### **2.2.1 Project/Site Supplemental Information**

The Erosion Prevention and Sediment Control (EPSC) Plans for the Initial, Interim, and Final Conditions (Drawings C-026 through C-037) have been revised to remove all proposed EPSC measures from the three (3) identified streams and to place additional controls adjacent to the streams. The revised EPSC plans accompany this supplemental information.

WASTEWATER TREATMENT PLANT EXPANSION  
BLEDSOE COUNTY CORRECTIONAL COMPLEX  
PIKEVILLE, BLEDSOE COUNTY, TENNESSEE SBC PROJECT 142/013-01-2013-06

JOB NO. N16003  
 ISSUE DATE November 30, 2018  
 SCALE 1" = 50' - 0"  
 DRAWING NO. C-032.1

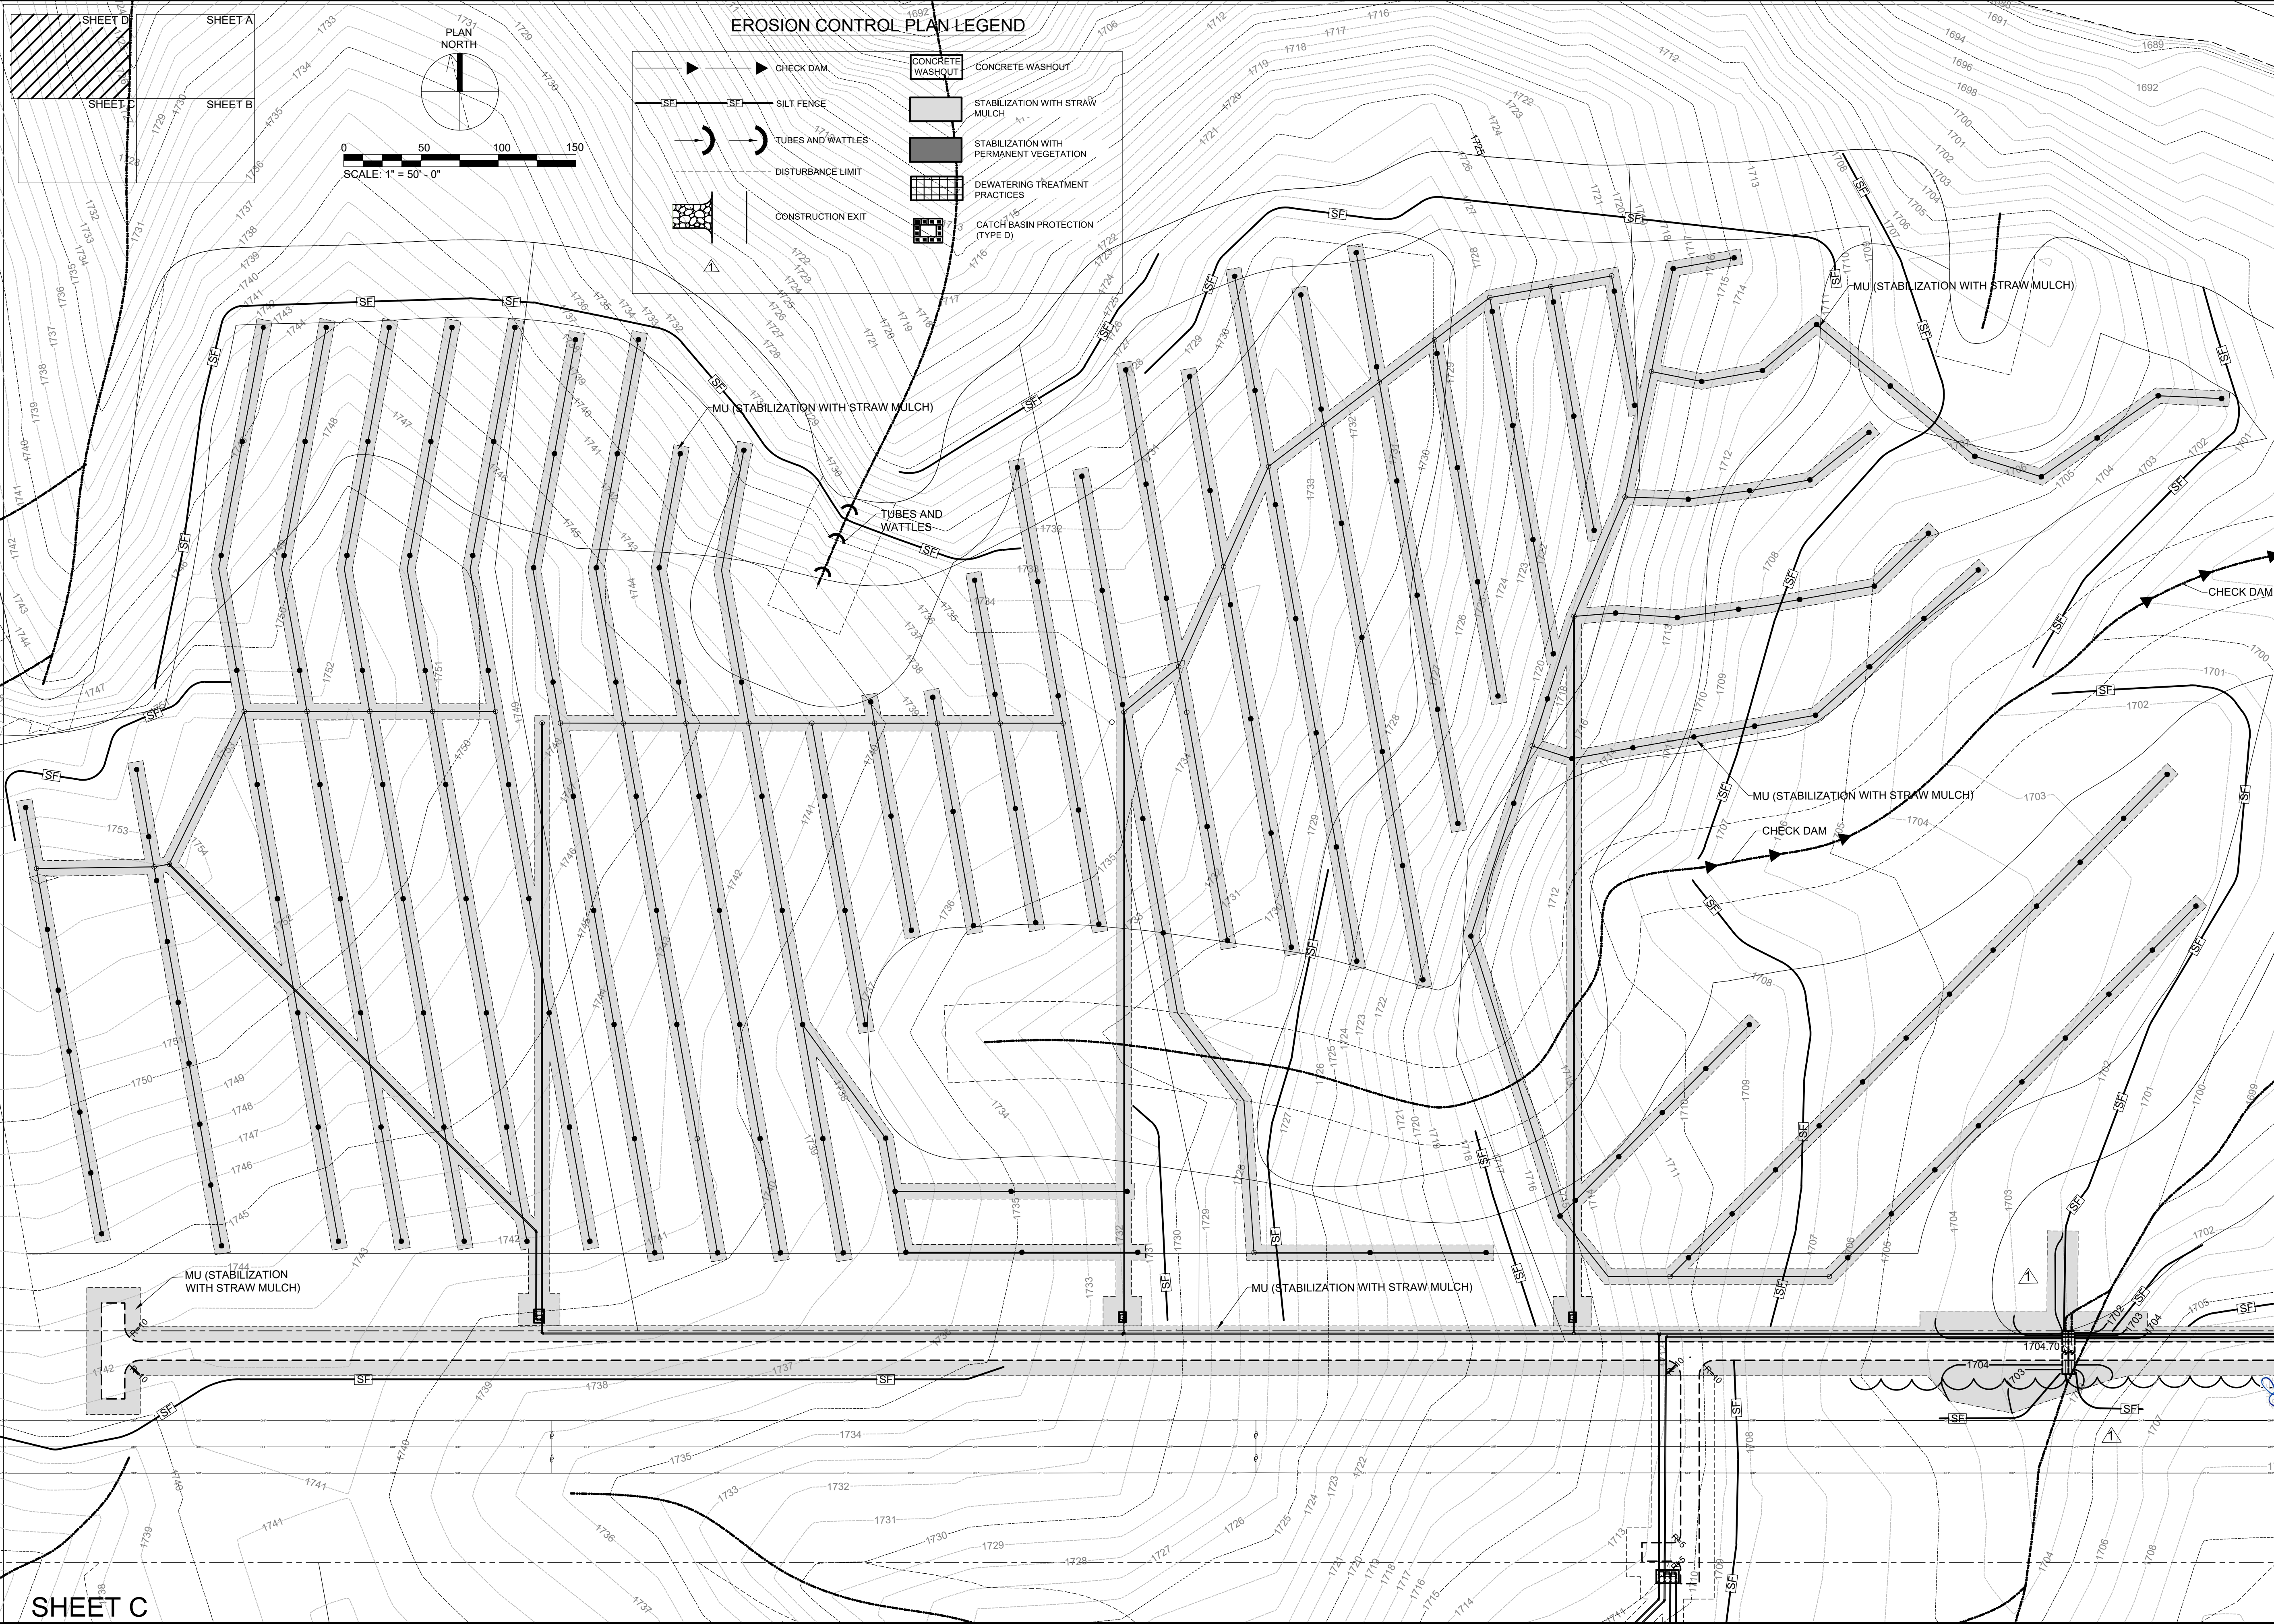
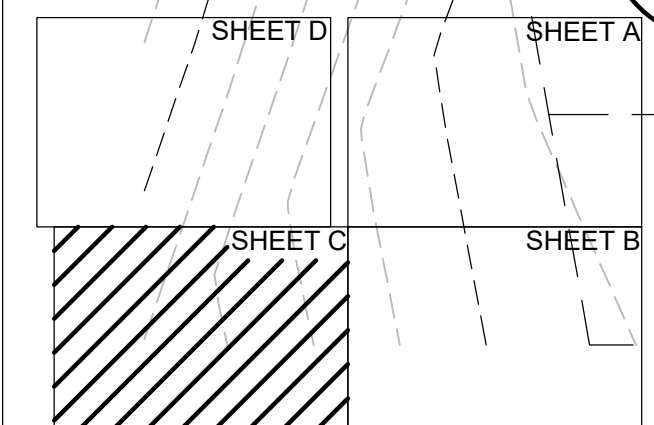
| REVISIONS |  | NO. | DESCRIPTIONS | DATE    | BY | APPD |
|-----------|--|-----|--------------|---------|----|------|
| Δ         | REMOVED EPSC MEASURES FROM DESIGNATED STREAMS, ADDED EPSC MEASURES ADJACENT. | 1   |              | 7/25/19 | NH | NH   |
|           | REVISED LEGEND   |     |              |         |    |      |

| DRAWING NO. | C-033.1           |

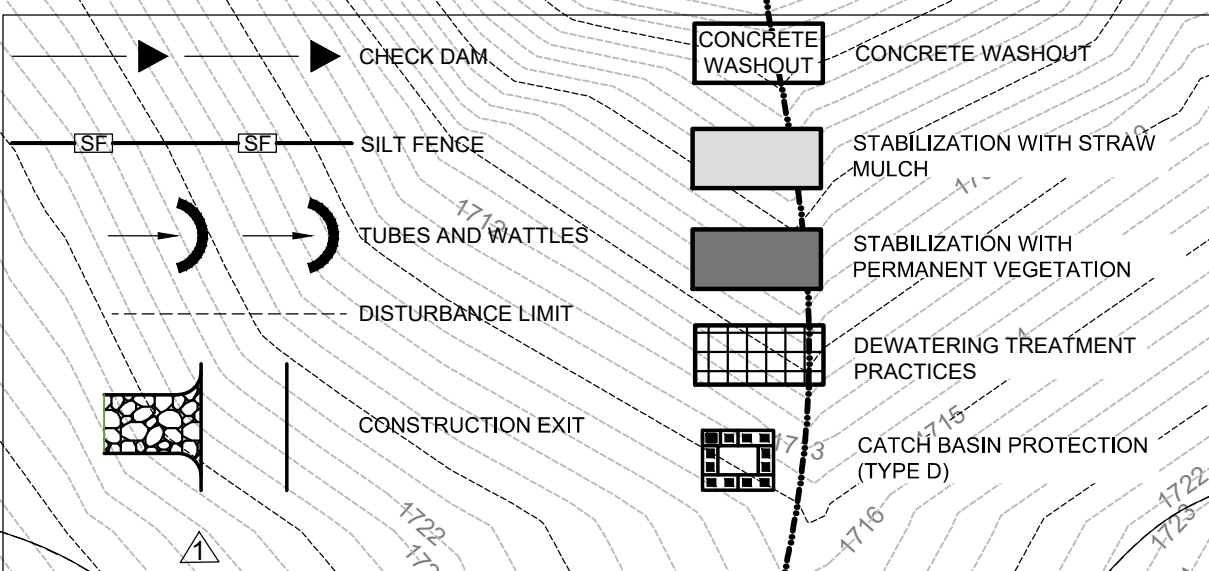
| REVISIONS |  | NO. | DESCRIPTIONS | DATE    | BY | APPD |
|-----------|--|-----|--------------|---------|----|------|
| Δ         | REMOVED EPSC MEASURES FROM DESIGNATED STREAMS. ADDED EPSC MEASURES ADJACENT. | 1   |              | 7/25/19 | NH | NH   |
|           | REVISED LEGEND.  |     |              |         |    |      |

DRAWING NO.  
C-034.1

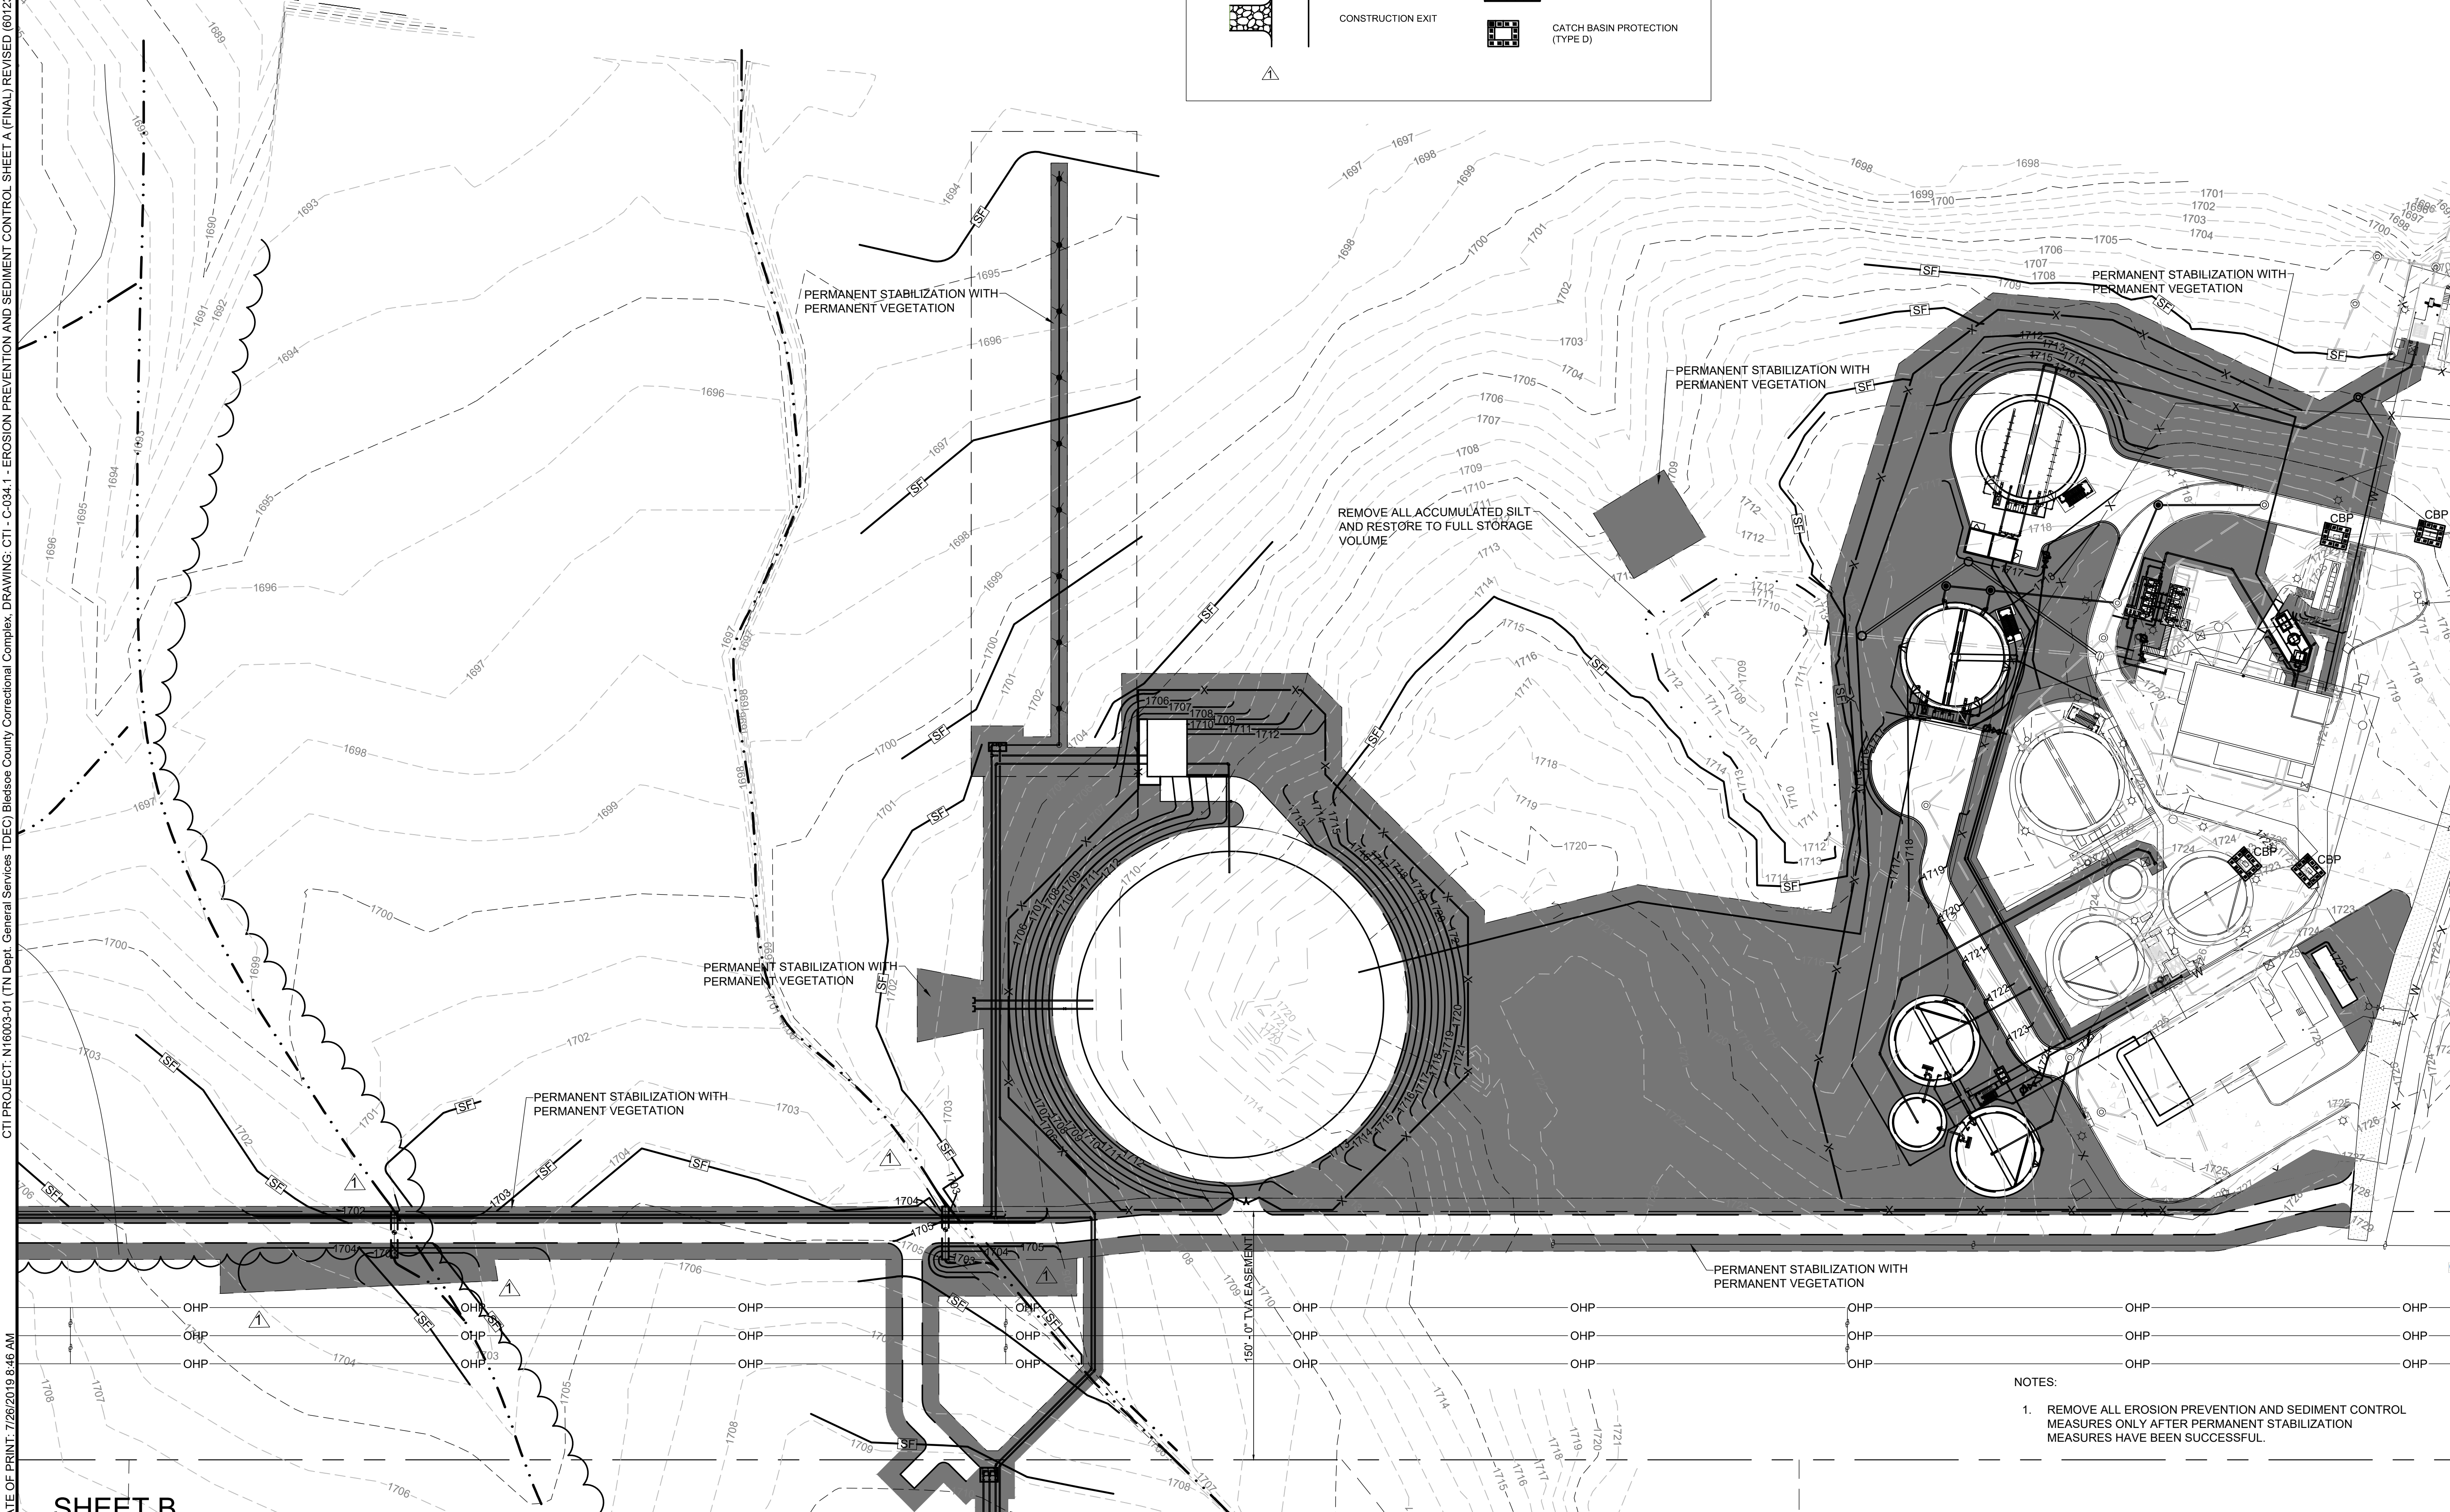
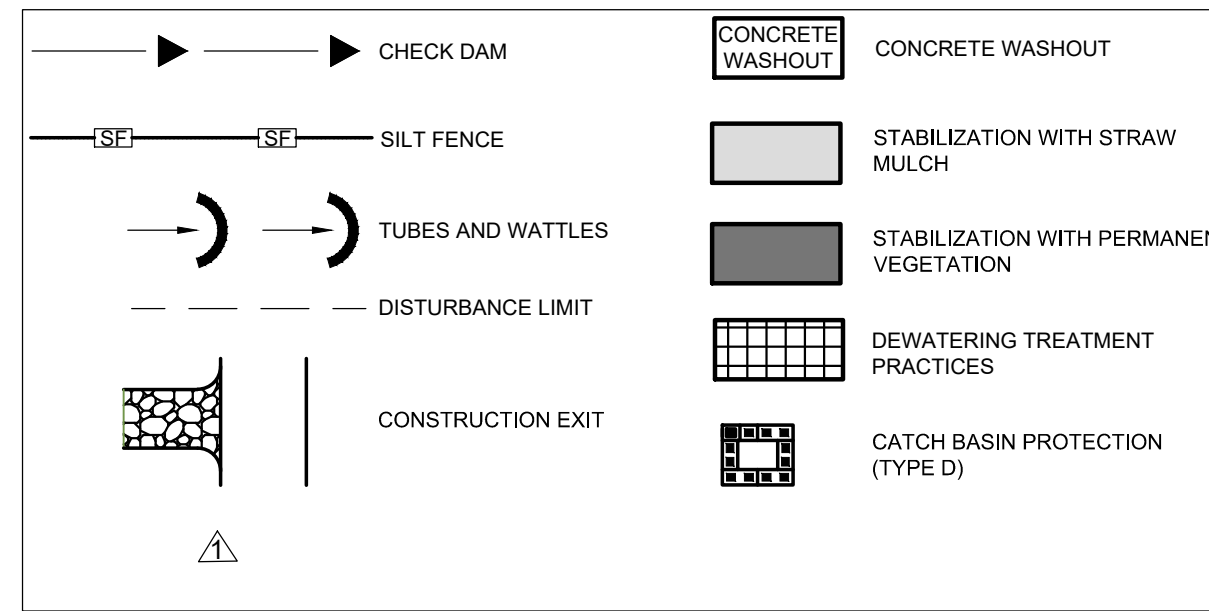
| REVISIONS |  | NO. | DESCRIPTIONS | DATE    | BY | APPD |
|-----------|--|-----|--------------|---------|----|------|
| Δ         | REMOVED EPSC MEASURES FROM DESIGNATED STREAMS, ADDED EPSC MEASURES ADJACENT. | 1   |              | 7/25/19 | NH | NH   |
|           | REVISED LEGEND   |     |              |         |    |      |

JOB NO.  
N16003  
 ISSUE DATE  
November 30, 2018  
 SCALE  
1" = 50' - 0"  
 DRAWING NO.  
C-035.1

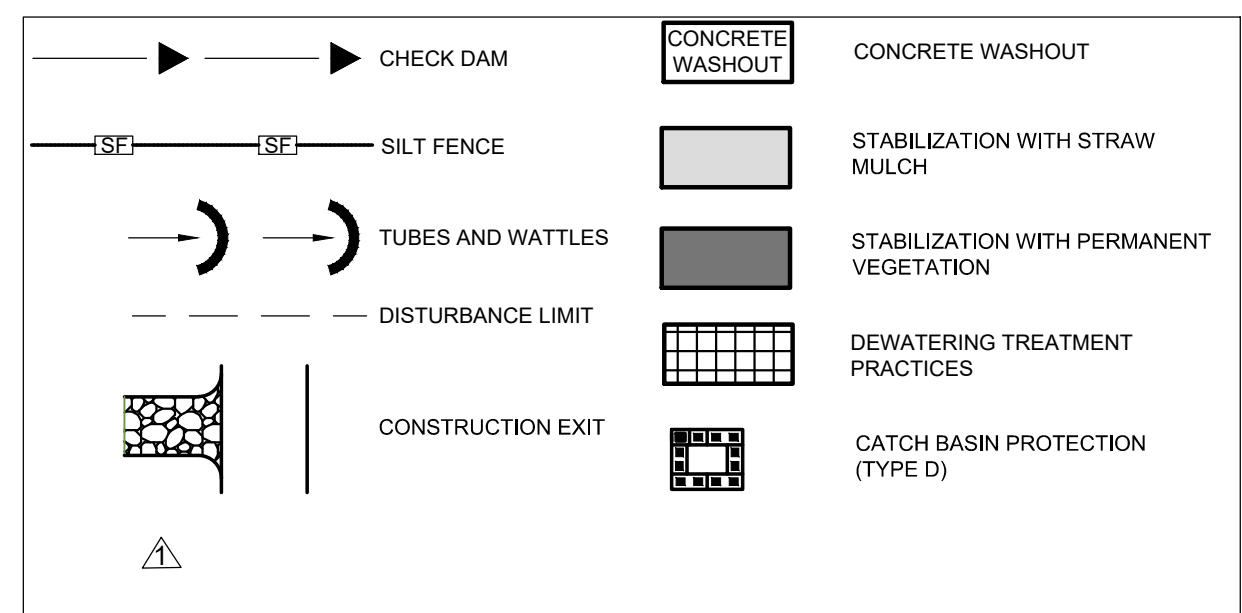
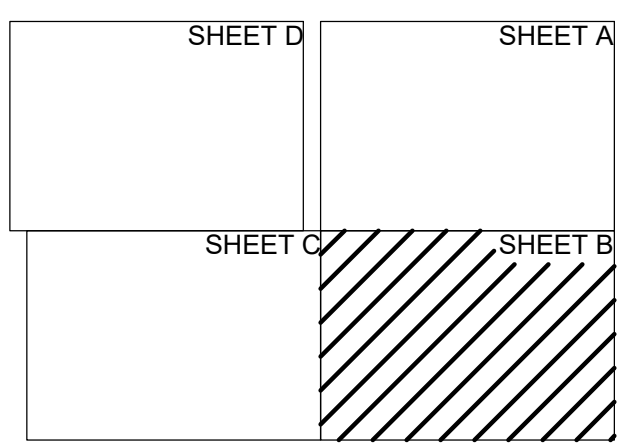
| DESIGN |         | REVISIONS |  |
|--------|---------|-----------|--|
| JRH    | 7/25/19 | 1         | REMOVED EPSC MEASURES FROM DESIGNATED STREAMS, ADDED EPSC MEASURES ADJACENT. |
| NH     |         |           | REVISED LEGEND.  |
